**NOTICE
OSHTEMO CHARTER TOWNSHIP
PLANNING COMMISSION**

**Thursday, July 30, 2020
6:00 p.m.**

To: Oshtemo Township Planning Commission

Request: Site Plan and Special Use approval to construct a new vehicle service facility

SITE PAVING AND UTILITY PLAN

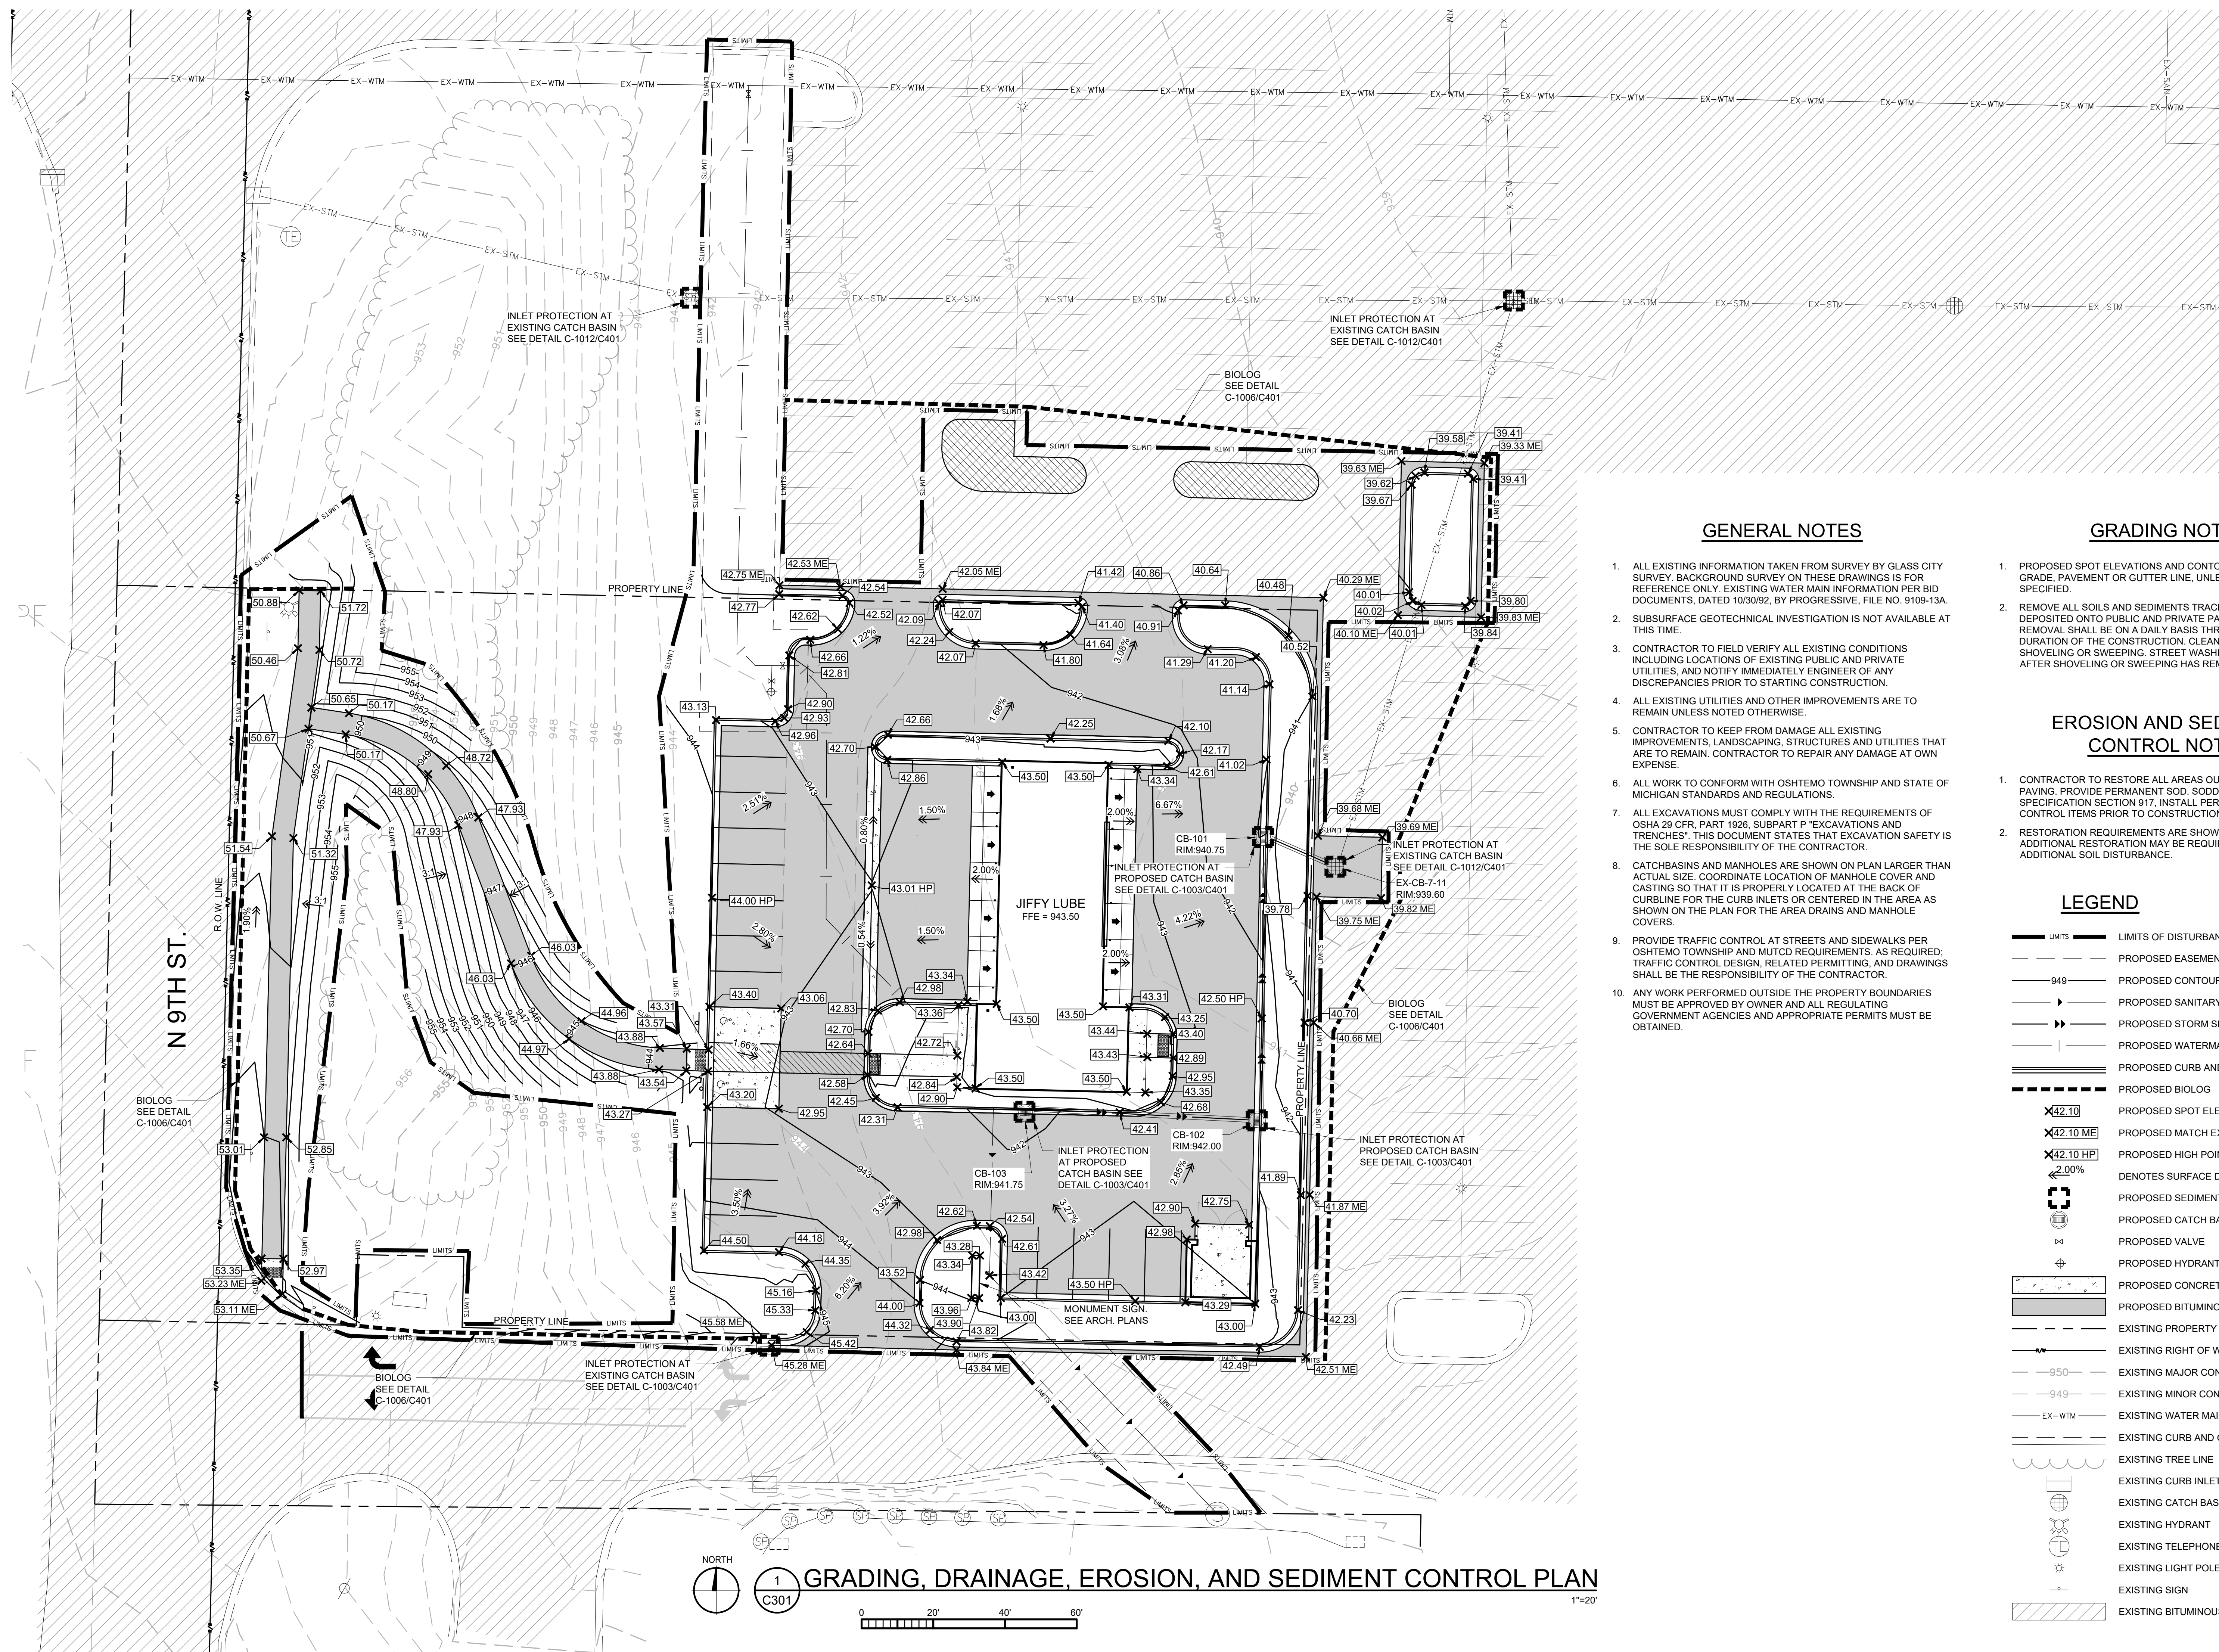
5. An updated Planning and Zoning Application shall be provided *prior to a building permit being issued*.
6. An updated Site Plan shall be submitted to the Planning Department *prior to a building permit being issued* with the following information.

- a. The pavement markings for the two existing driveways to N 9th Street will be modified to help with traffic control and safety - the outside right turn lane turned into a right or through lane.

- b. Final plans for the 6-foot-wide concrete sidewalk to run along this section of N 9th Street.
 - c. An update to the location/zoning map marking the specific location of the site plan being reviewed.

- d. Show the proposed setbacks of the building on the plans.

- e. Show the location of where the above ground and underground storage tanks will be on site.
- f. The applicant shall address the following items with the Township Fire Marshal:

PLANTING PLAN

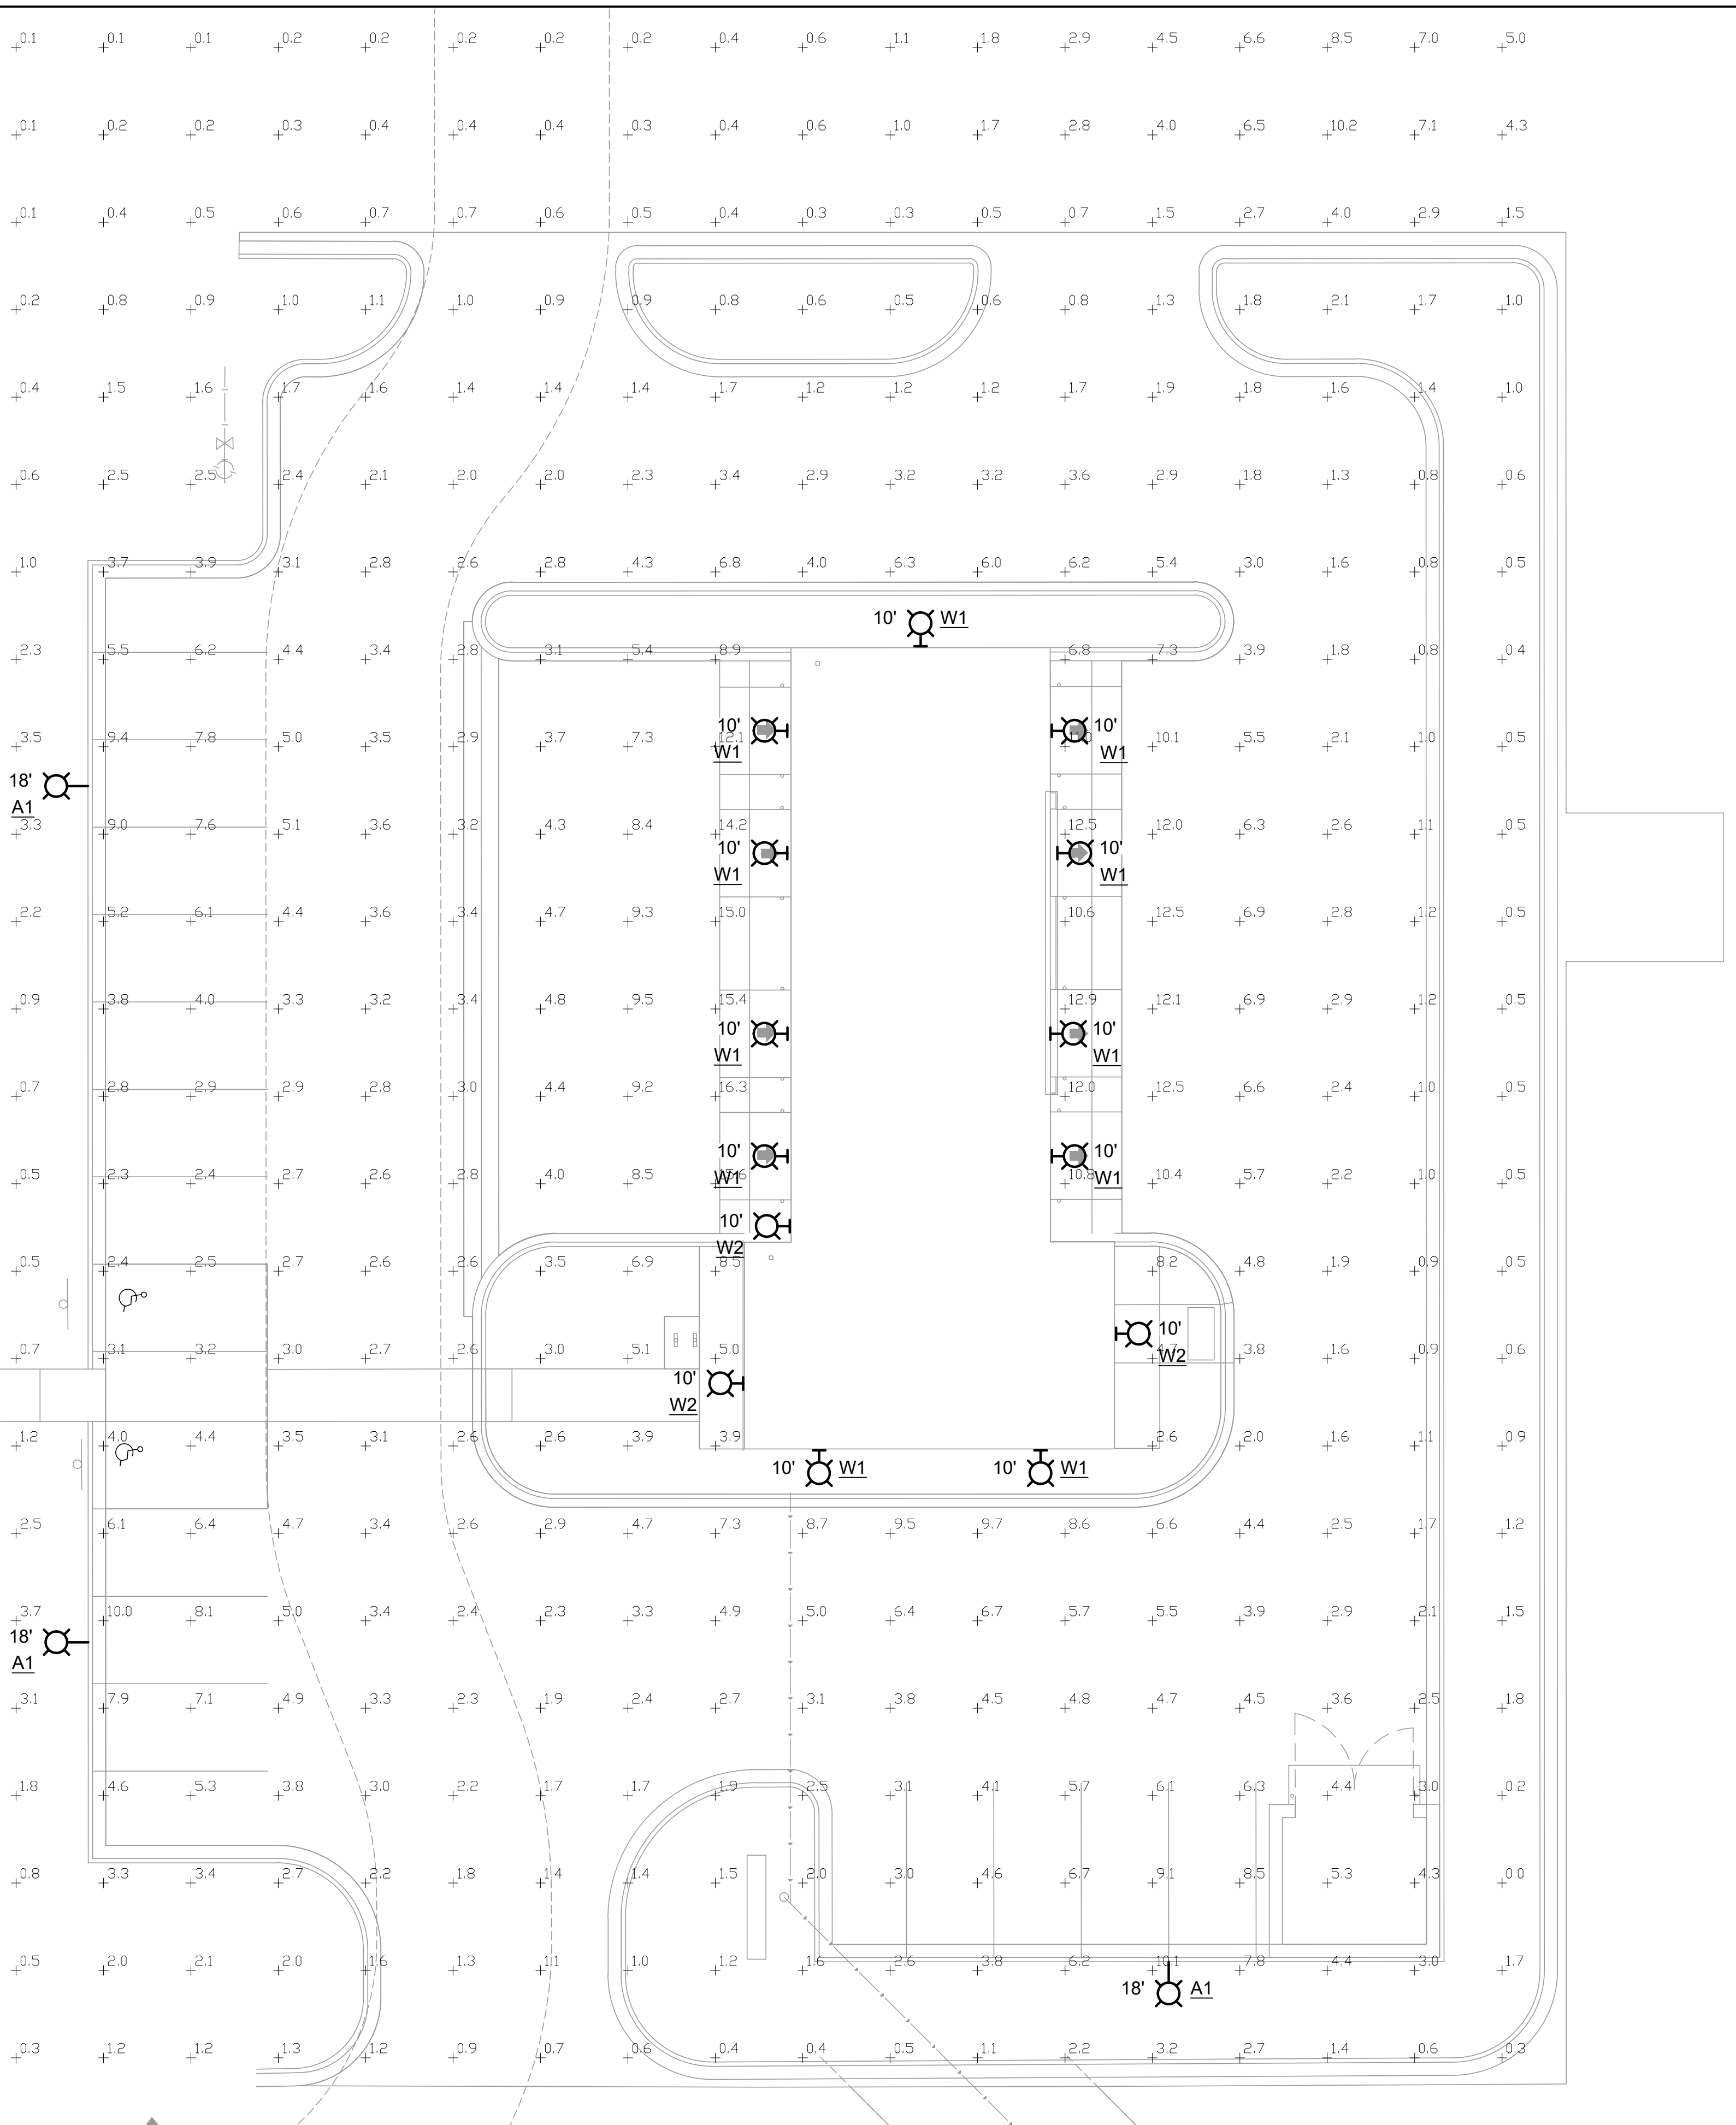
9. An updated Landscaping Plan shall be provided to and approved by the Planning Department *prior building permit issuance*. Current concerns include:

- a. A total of 10 canopy trees, 20 understory trees, and 4 shrubs are required. The number proposed far exceeds this and will be very costly to plant and maintain over time on this limited site (25 canopy trees, 29 understory trees, 82 shrubs, and hundreds of one gallon pots of groundcover). Please be aware that all landscaping shown on the approved plan must be installed before a certificate of occupancy is granted. It must be maintained in order to stay in compliance. It may be preferable to submit a landscape plan that meets the minimum requirements then add more landscaping later if desired.

- b. Our ordinance has the following provision regarding monocultures: "The use of a single species is prohibited to increase the rate of plant survival. Except for plantings used for evergreen screening, no one species of tree or shrub may make up more than 50% of the total amount within each Plant Material Type." Based on the number of trees required (not proposed) no more than 5 of the canopy trees can be maples and no more than 10 of the understory trees can be paw paws. Other canopy tree species to consider are oak, basswood, or hackberry. Other understory tree species to consider are serviceberry, American hornbeam, or redbud.

- c. Minimum sizes at planting must be revised as follows: canopy trees – 2" caliper, understory trees – 8' height.
